## 2095 Dilworth Road, Kars, ON

### Servicing Options and Conceptual Stormwater Management Report

**Reference: 2095 Dilworth Road  
Response to City Technical Review Comments  
City File No.: D02-02-24-0029  
Novatech File No.: 123081**

SCALE 1 : 4000  
DATE SEPT 2026  
JOB 123081  
FIGURE 3

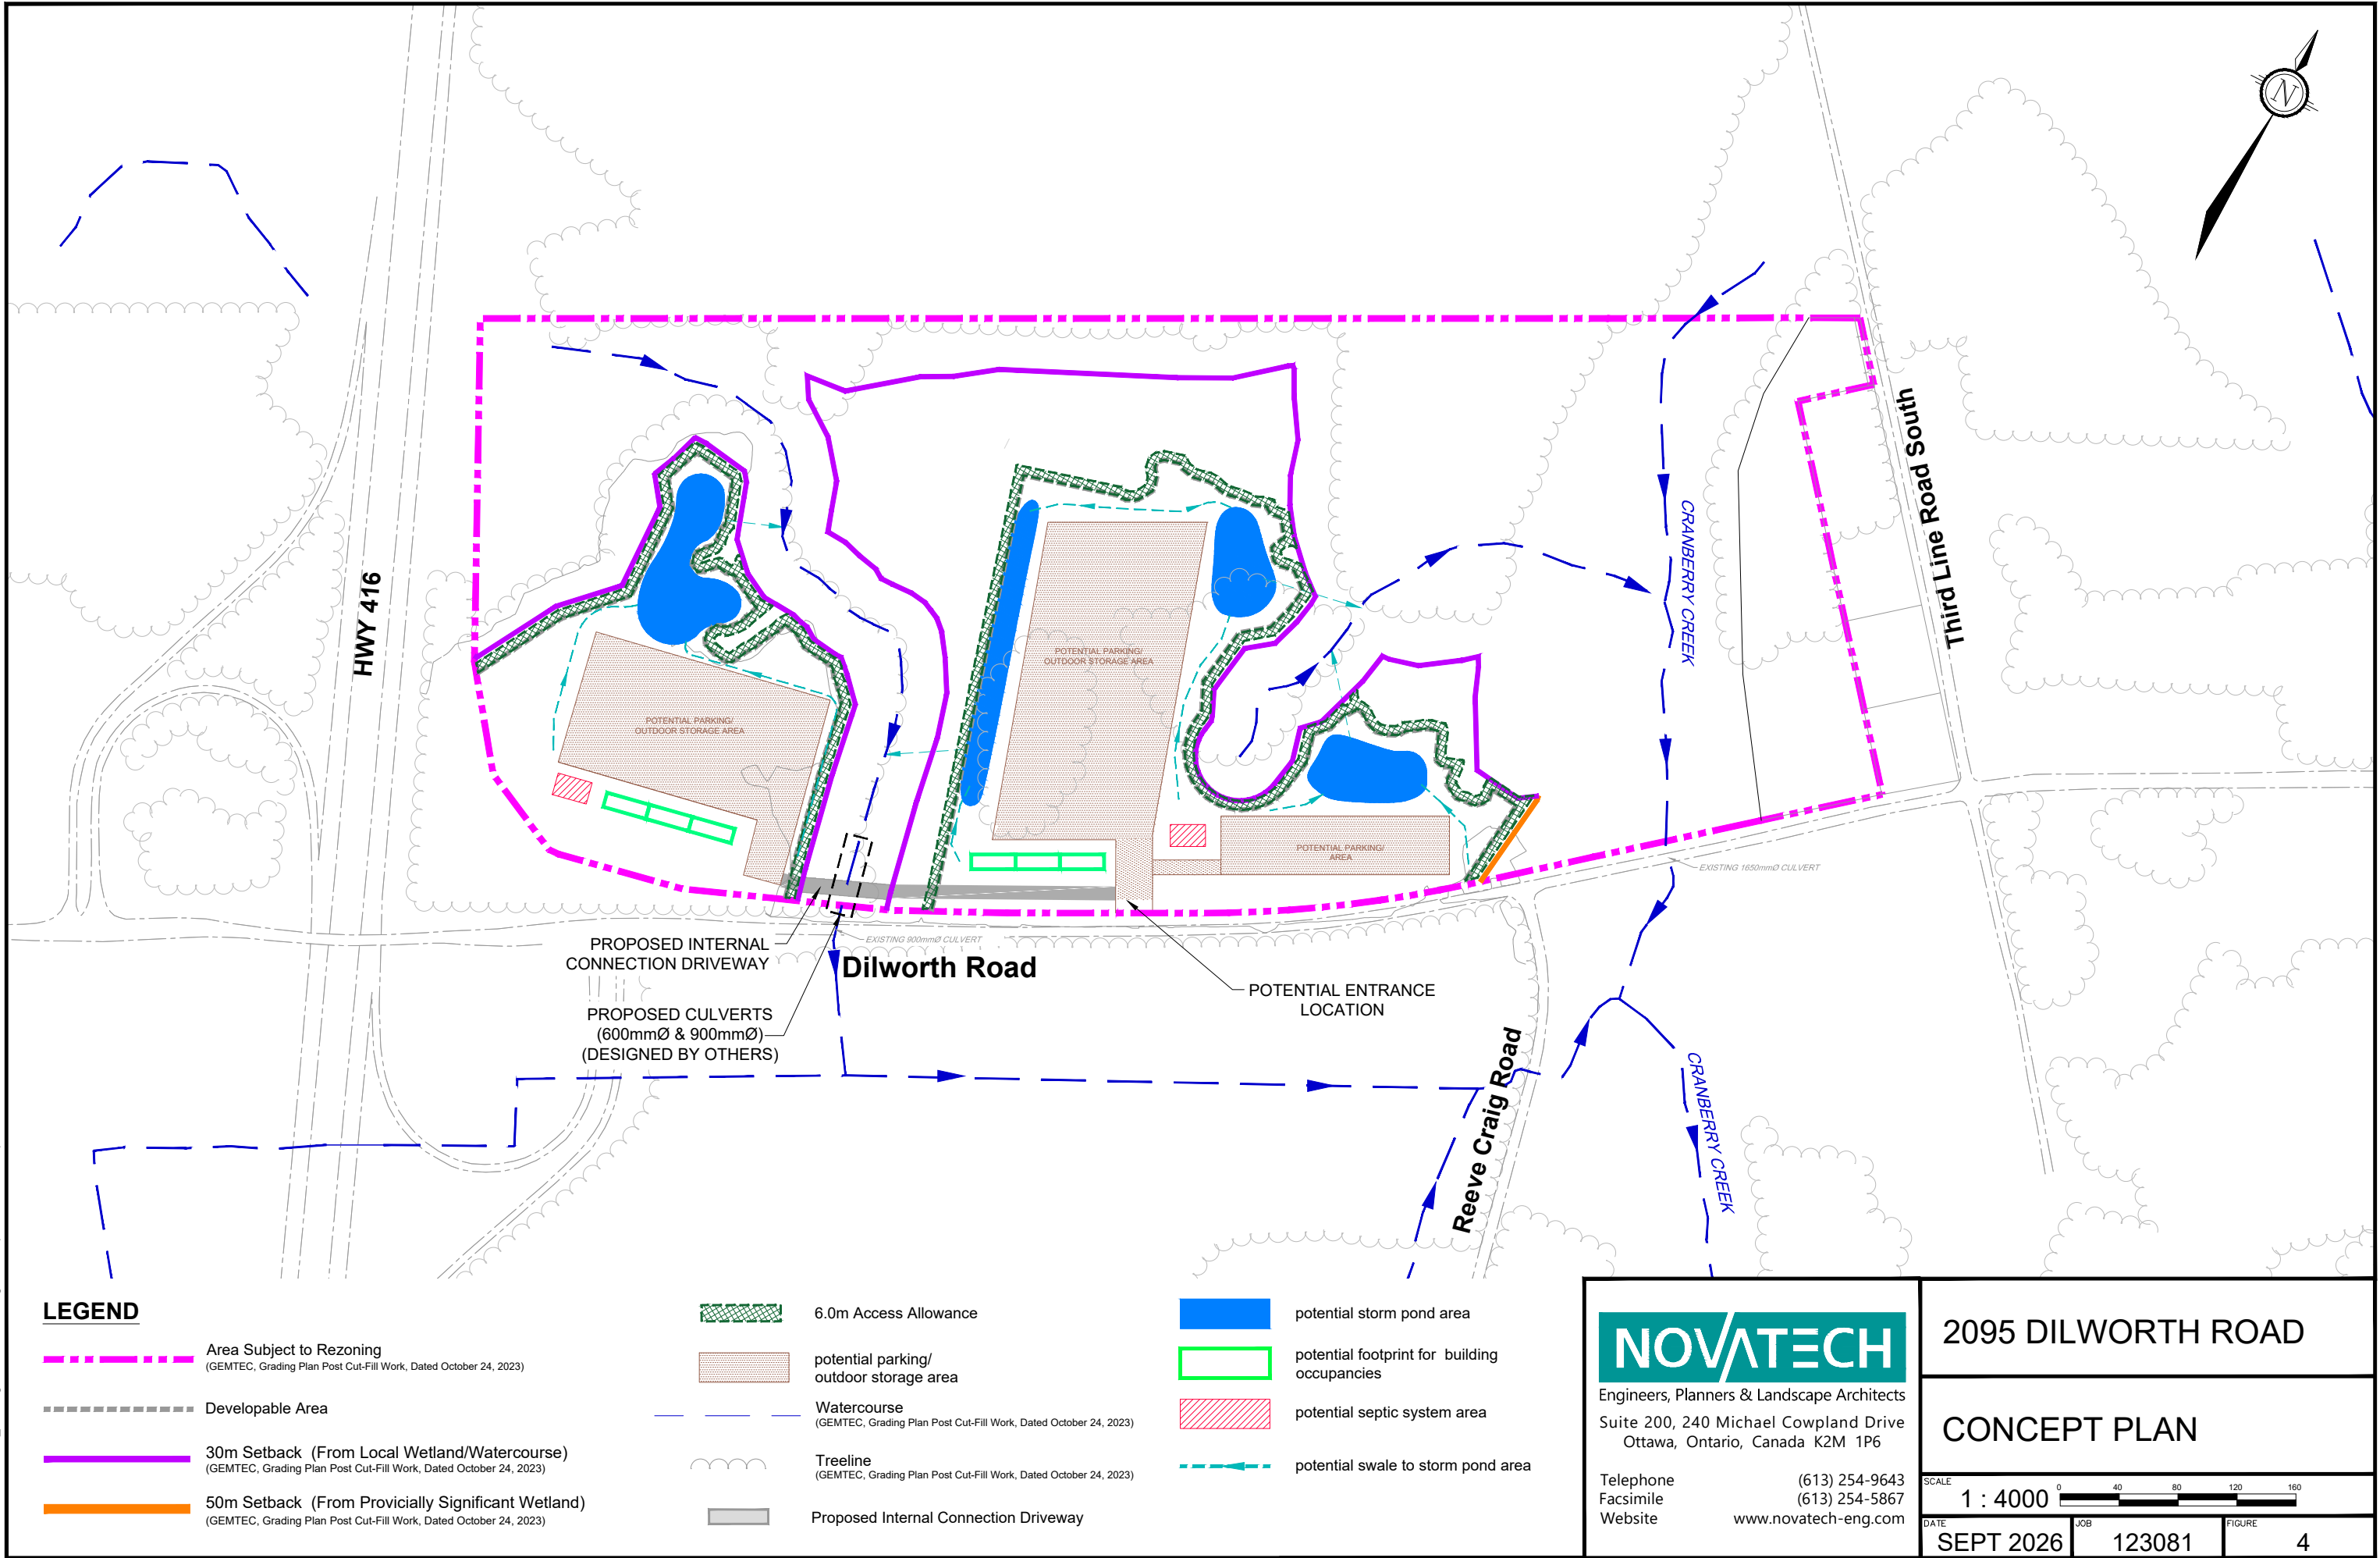
10. Figure 3 of the report only shows directions at the outlet points. The figure should be revised to show complete overland stormwater flow directions. **This comment was not adequately addressed in the report.**

| FILE NO. | 65007.01 | SHEET NO. | C1 |

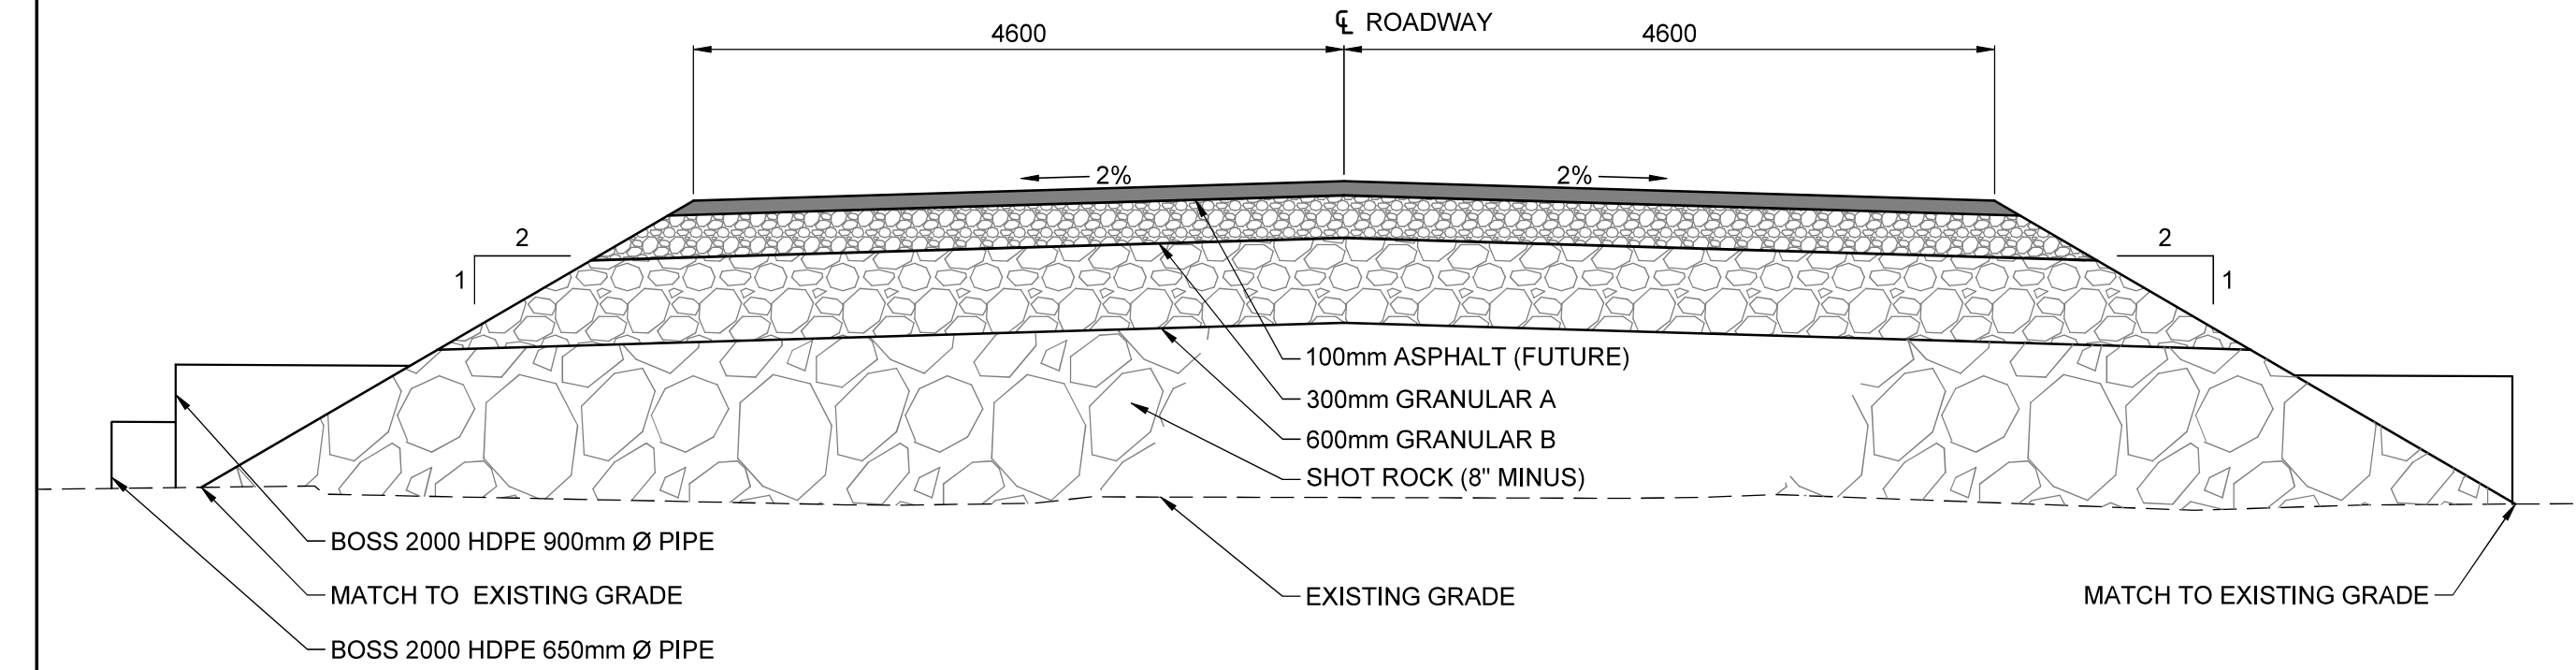
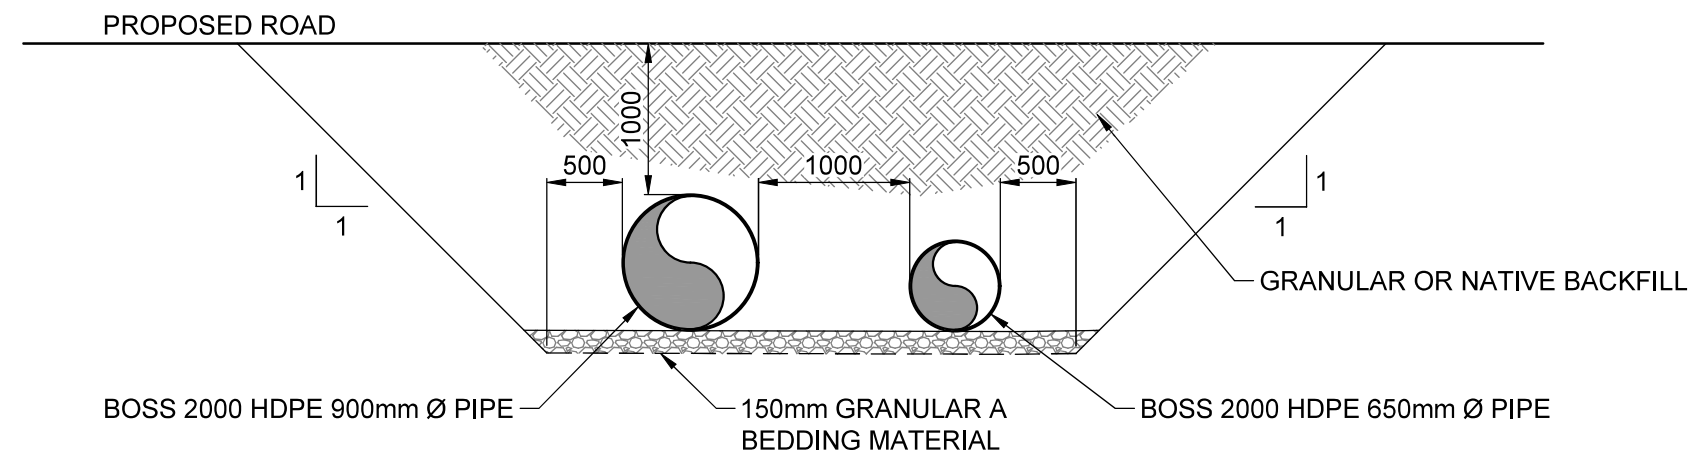
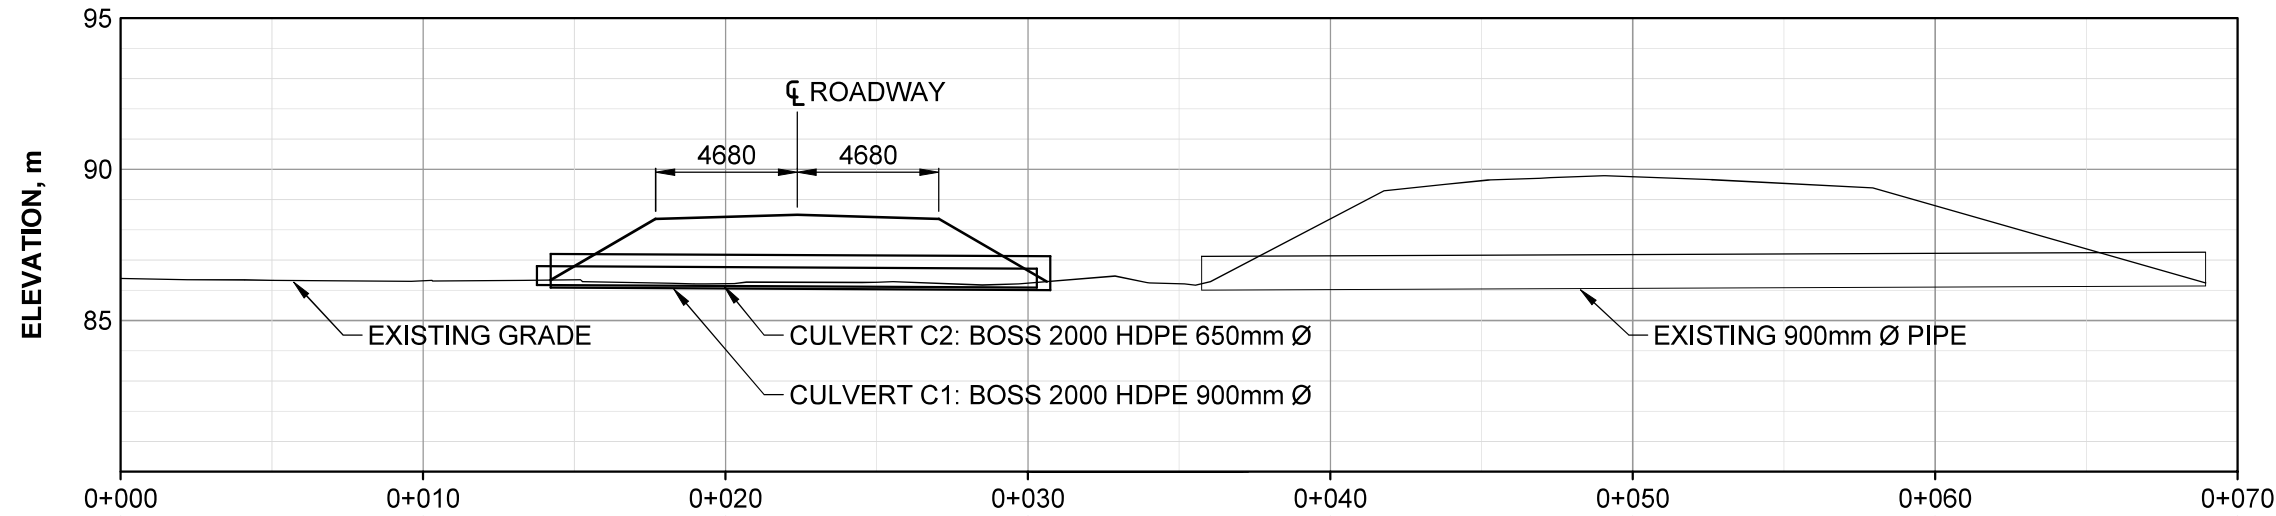
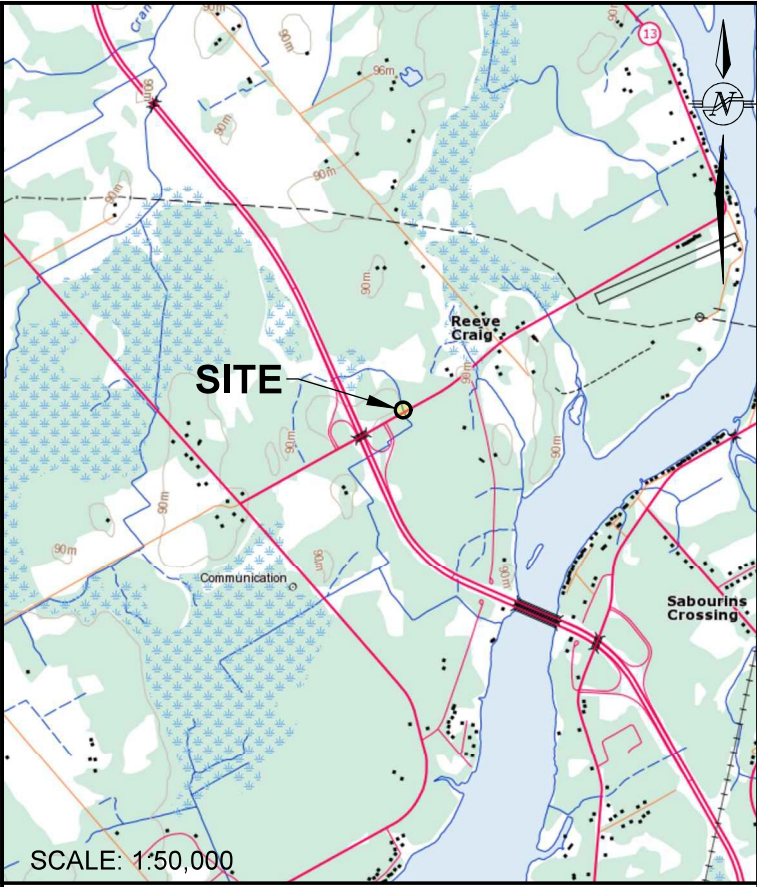
11. The design proposes two culverts (900mm and 600mm) within the roadway connecting Area 1 and Area 2. Plan C1 in Appendix A shows the road culvert with a diameter of 900mm. The two proposed culverts will discharge directly into the road right-of-way ditch and the roadway culvert with a lower conveyance capacity. The 900mm road culvert capacity, the roadside ditch capacity and the potential roadside ditch erosion were not discussed in the report in the post development condition.

Please determine peak volumes exiting the proposed culverts and provide evidence and rationalize thoroughly in the report that the proposed culverts will not negatively impact the stormwater management in the municipal right-of-way during 2-year, 5-year, 10-year, 25-year, 50-year and 100-year storm events. It should be noted that, previously, flood plain water would rise gradually and outlet via the road culvert, while now it will be raised behind the proposed culverts and forced via two culverts into the right-of-way and subsequently into a smaller-diameter road culvert.

*Novatech Response: Wording has been added to the report as requested.*
